Assessment of the DCH Issue for Plants with Ice Condenser Containments

Sandia National Laboratories

This report (NUREG/CR-6427) addresses the Direct Containment Heating (DCH) issue for all Westinghouse plants with ice condenser containments. There are ten operating ice condenser plants located at five sites in the U.S. DCH phenomena in ice condenser plants are different in some important aspects from DCH phenomena in other Pressurized Water Reactors (PWRs) in that they have ice beds to suppress Design Basis Accident (DBA) steam loads, AC-powered igniters to control hydrogen concentrations in the atmosphere, small containment volumes, and containment buildings with low ultimate capacities to withstand internal pressures.

Figure 5.9 Prediction of ice inventory for various modeling approaches

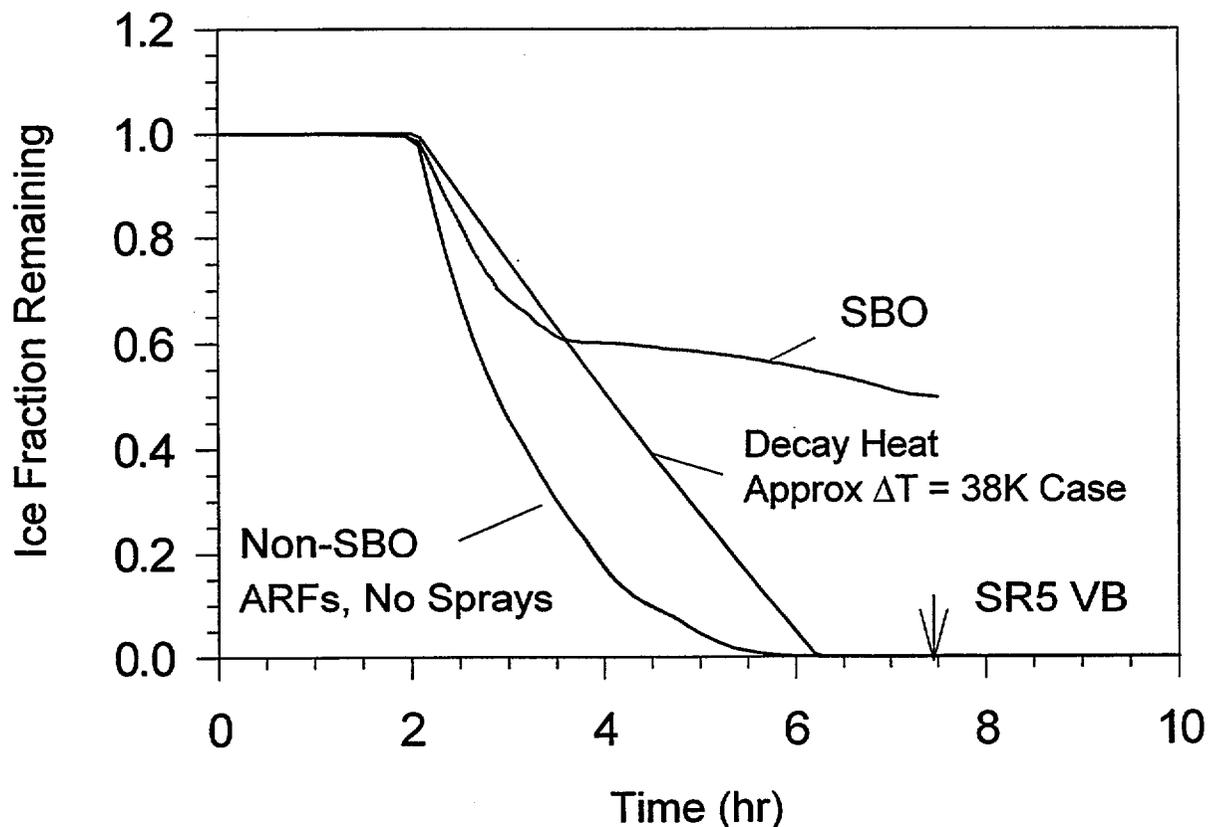
3. Considerable time is spent during the CONTAIN calculations (Section 5) to prove that the ice beds will be depleted before vessel breach and containment loadings for a dry cavity are provided. Those are irrelevant for several reasons: (1) the reactor cavity will be flooded and (2) there is a high probability that the plant will be depressurized. A correct SCDAP/RELAP/CONTAIN calculation would validate those results for non-SBO and SBO conditions. This also can be inferred from Figure 5.9.

Figure 3.2 Screening margin and pressure energy ratio

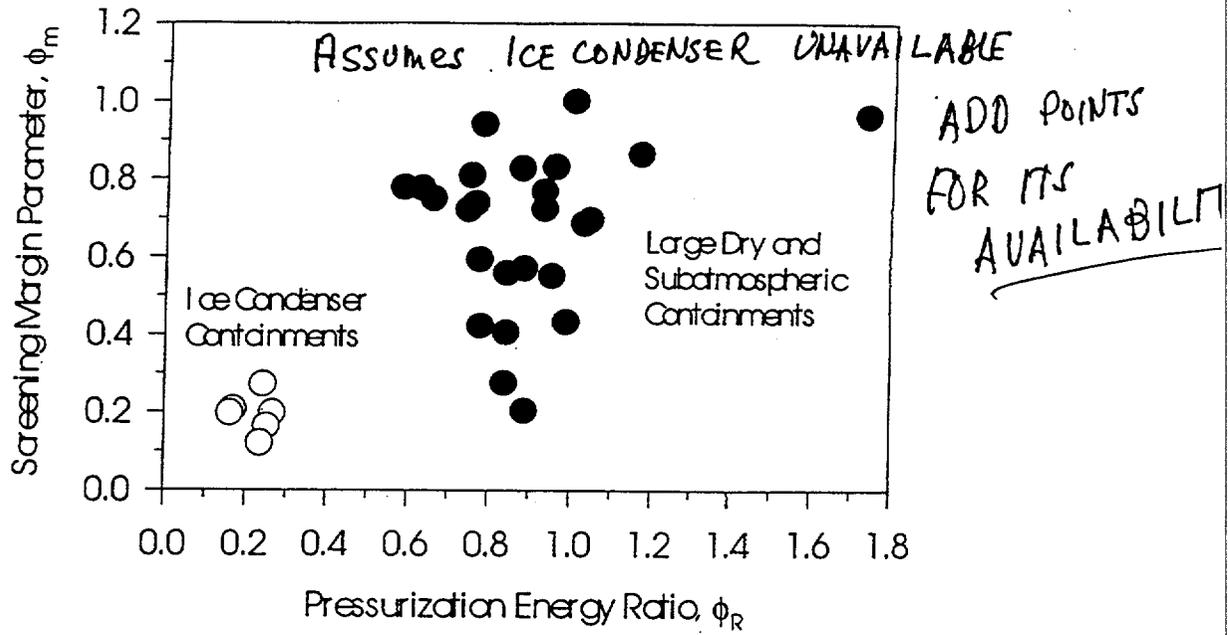
wrong values again
Other DCH Phenomena: Other DCH-related phenomena include the rates of thermal and chemical interactions of gas and steam with airborne and nonairborne debris, debris airborne residence times, fraction of debris dispersed from the cavity, and coherence between debris dispersal and blowdown steam. No major differences between large dry containments and ice condenser containments have been identified concerning these phenomena.

Figure 3.3 Hydrogen and Zr/ UO_2 ratio parameters

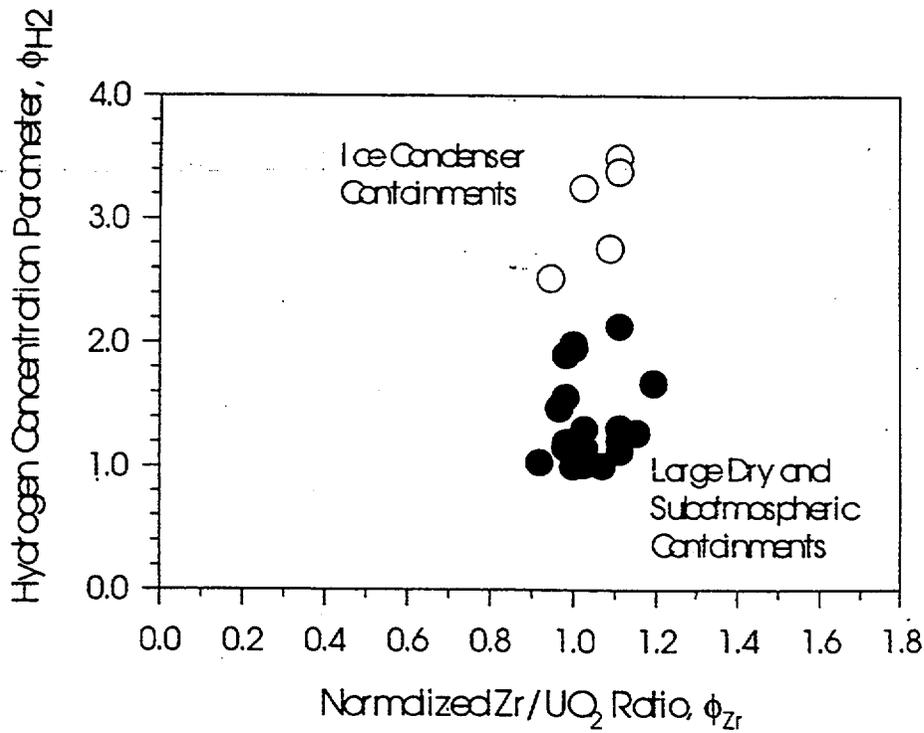
*Refer to
As discussed
Event to DCH*
*See herein
Comments*
